INVESTIGATION OF PRICE ESTATES)	
SUBDIVISION WASTEWATER TREATMENT)	
SYSTEM AND ROBERT TRIMBLE)	
_____)	CASE NO. 91-071
)	
ALLEGED VIOLATION OF KRS CHAPTER 278)

O R D E R

UTILITY REINSPECTION REPORT

Price Estates
Johnson County, Kentucky

7/31/90
PRICE ESTATES
SLUDGE IN CLARIFIER

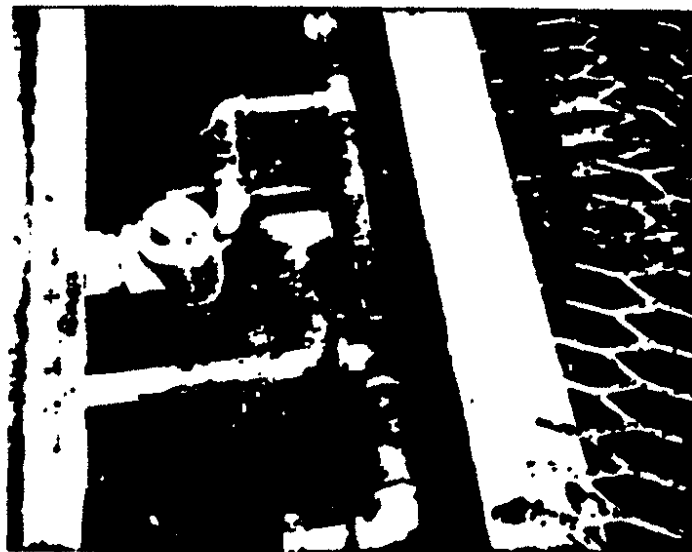
1. The diffusers need to be inspected and repaired or replaced as necessary. (807 KAR 5:071, Section 7, 1)
2. The chlorination unit needs to be repaired and put in service. (807 KAR 5:071, Section 7, 1)
3. The chlorine contact basin needs to be cleaned of sludge. (807 KAR 5:071, Section 7, 1)
4. A backup blower and motor unit or immediate access to one is needed in case of an emergency. (807 KAR 5:071, Section 7, 1)
5. The clarifier needs to be cleaned out. (807 KAR 5:071, Section 7, 1)
6. The aeration tank is almost in a septic condition giving off a slight hydrogen sulfide odor. The air discharge rates need to be increased to help this problem. (807 KAR 5:071, Section 7, 1)
7. The skimmer needs to be inspected for proper operation and repaired if found not operating properly. (807 KAR 5:071, Section 7, 1)
